#### Modification Bulletin

| Model: Martini-C1 LCT (RT43) / B4/LG Kit / A3/DLT Kit Dat |                          |        |                       | e: 9-Jan-03 |        | No.: MB473001  |
| Modified Article: C                                       | ase Seal                 |        | Prepared by: K. Miura |             |        |                |

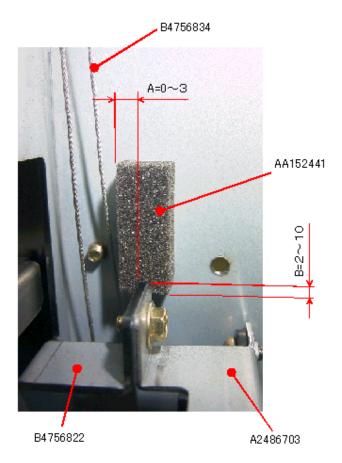
The following has been added to ensure that the wire shown below does not come out of position, which can occur when the A3/DLT kit is forcibly closed while there is slack in the wire (see the next page for the attachment position).

| Old part<br>number | New part<br>number | Description | Q'ty | Int | Page | Index | Note |
|--------------------|--------------------|-------------|------|-----|------|-------|------|
|                    | AA152441           | Case Seal   | 1    |     | 19   | 25    |      |

Model: Martini-C1 LCT (RT43) / B4/LG Kit / A3/DLT Kit Date: 9-Jan-03 No.: MB473001

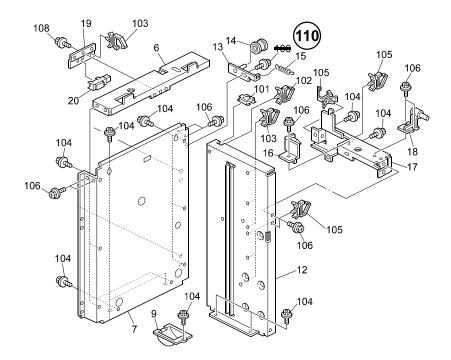
#### In the Field:

Please add the Case Seal as follows:
